No. UPMRC/CE-Contract/LKPD-10/2022-23

ADDENDUM-2

Tender Title/Name of work: LKPD-10: RFP for developing, setting up, operating and maintaining commercial spaces through licensing at various metro stations of N-S Corridor of Uttar Pradesh Metro Rail Corporation at Lucknow.

Tender LKPD-10 : Summary sheet for Addendum-2

Page No.49R

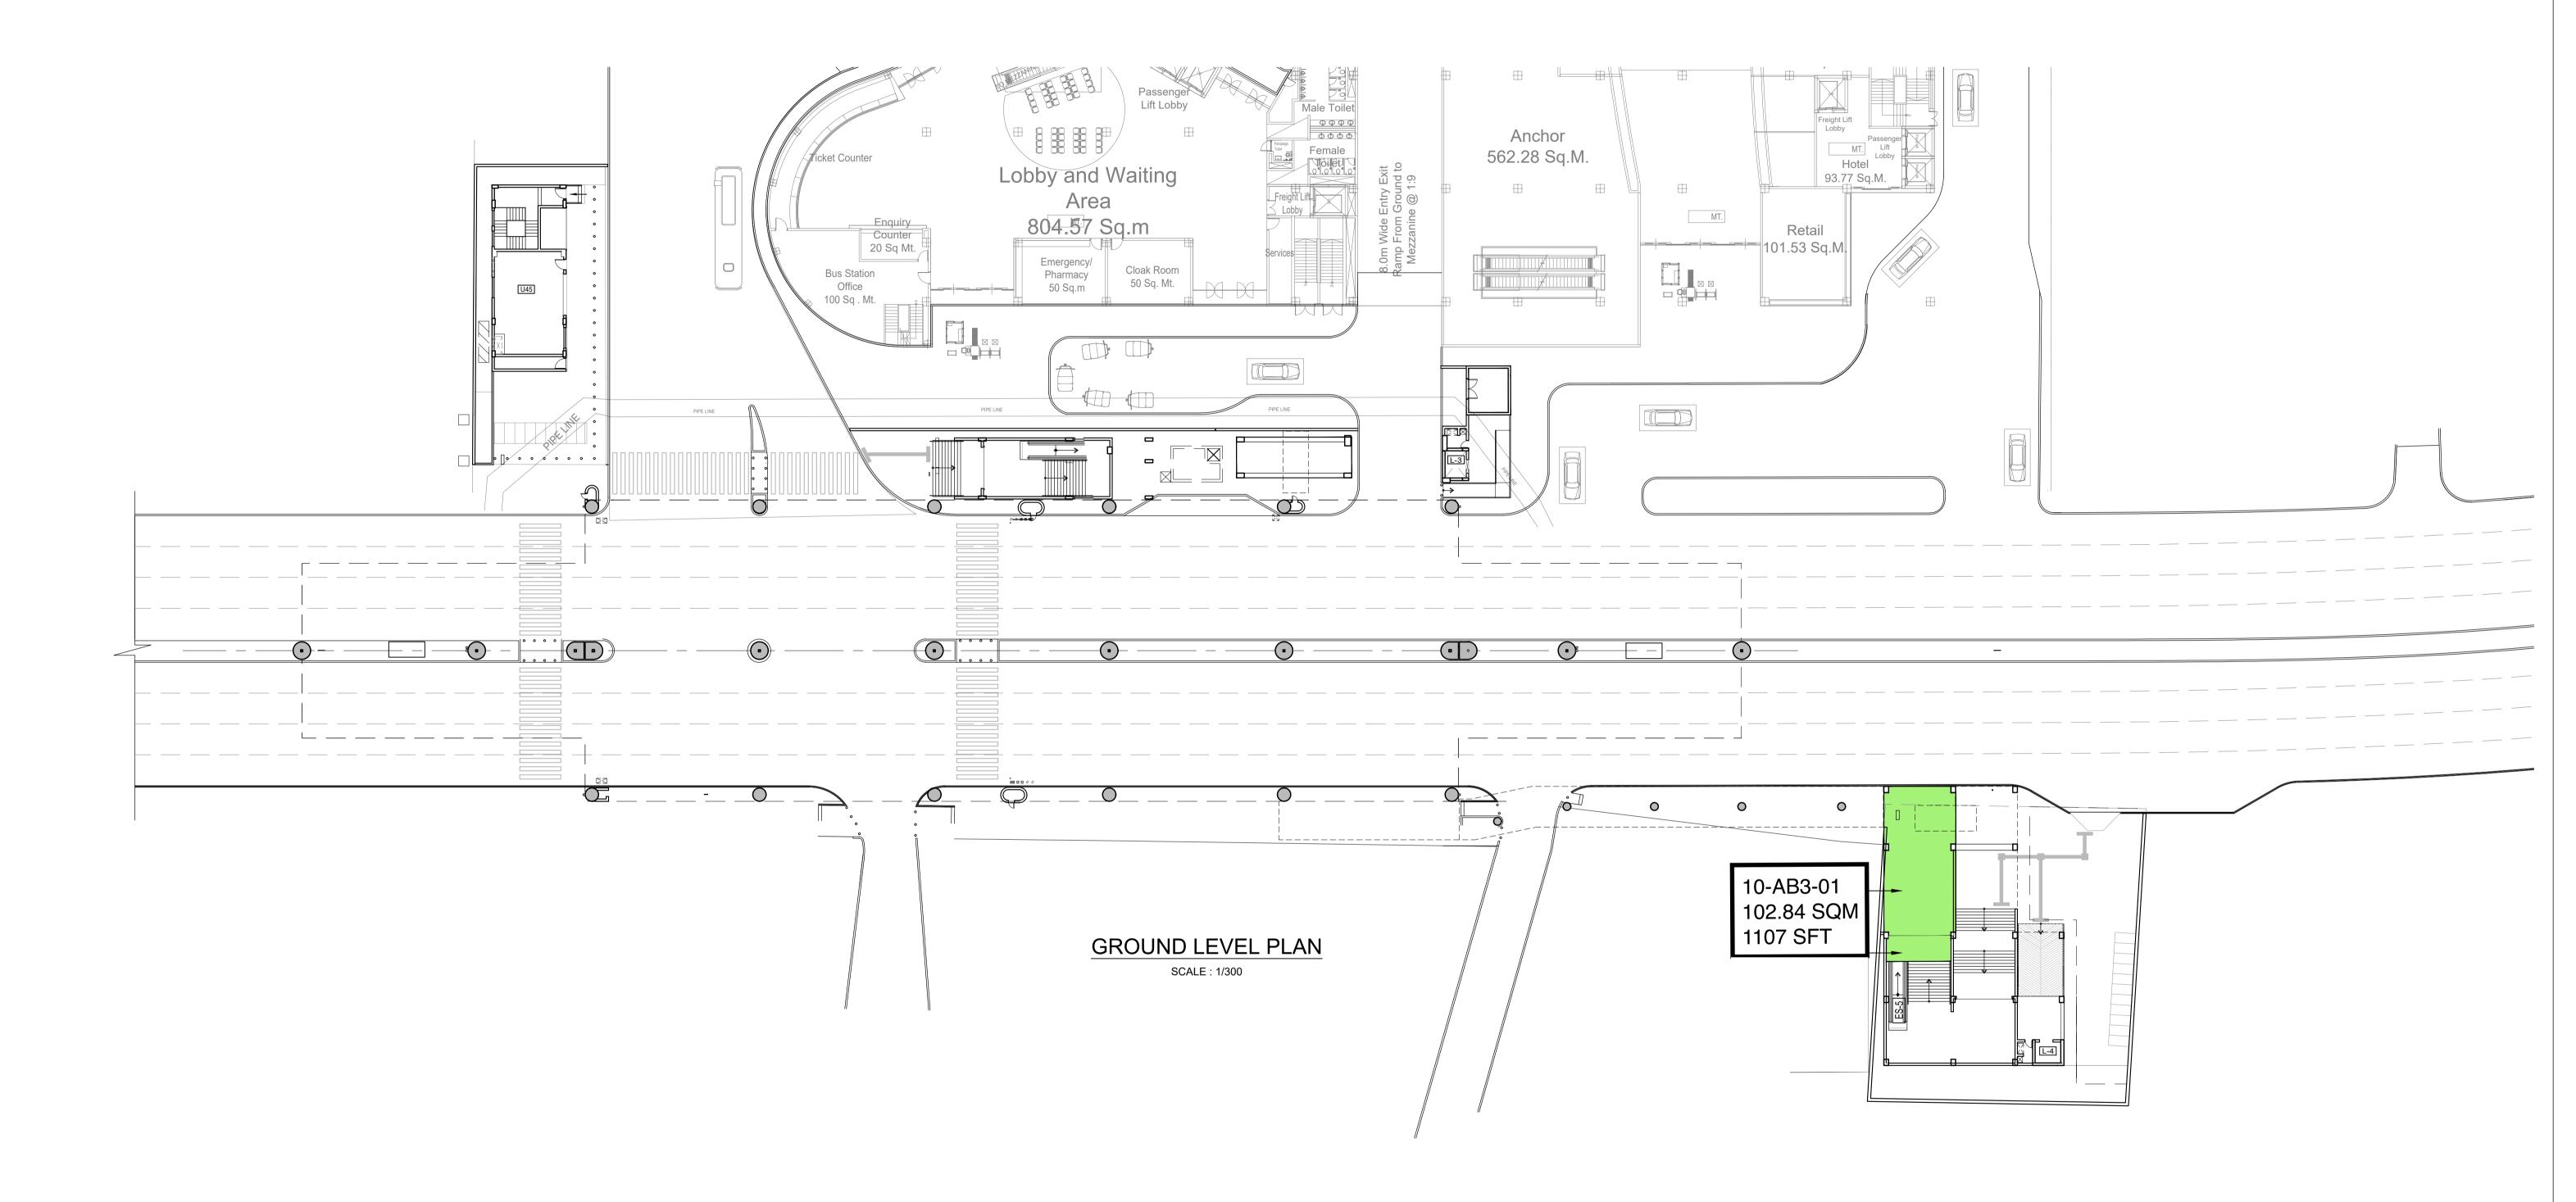
| S. NO. | Existing Clause / Pg. No. | Clause in Existing Tender Document | Revised Clause | Revised Clause placed as Annexure/ Pg. No. |
|-----------|---|------------------------------------|---|--|
| 4 | Drawing No-2 | Drawing no. 2 | Please refer revised drawing no. 2 R, page no. 49 R (one space added in drawing as 10-AL1-04) | Please refer Annexure-D of Addendum-2 Page 49 R |

Page No.56R1

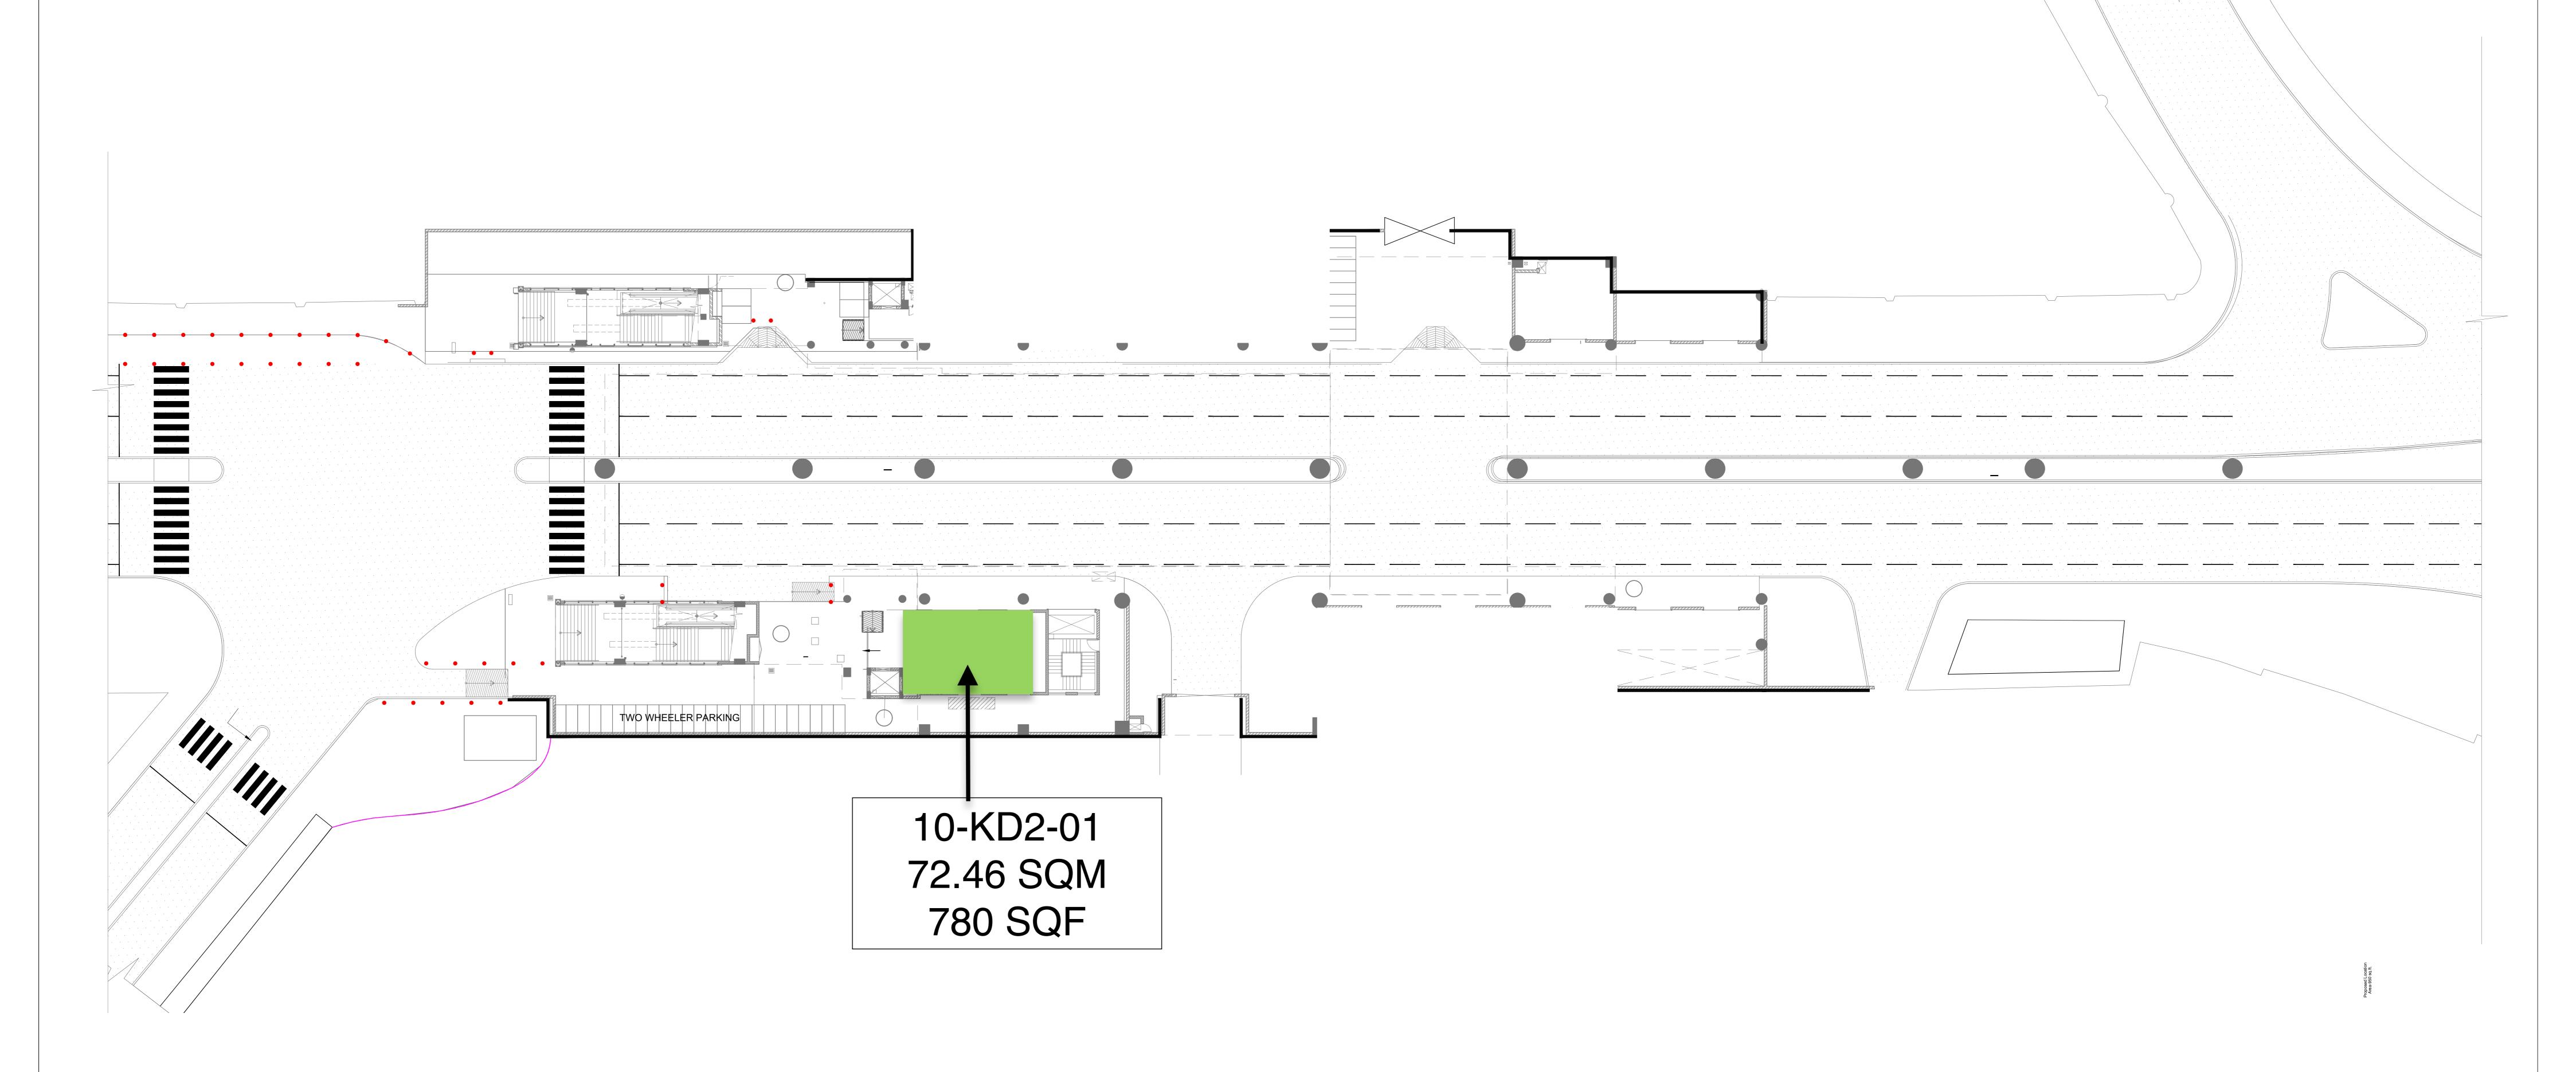
| 6 | Drawing No-9 | Drawing No-9 | Please refer revised drawing no. 9R1, page no. 56 R1 (one space added in drawing as 10-AB3-01) | Please refer Annexure-F of Addendum-2 Page 56 R1 |
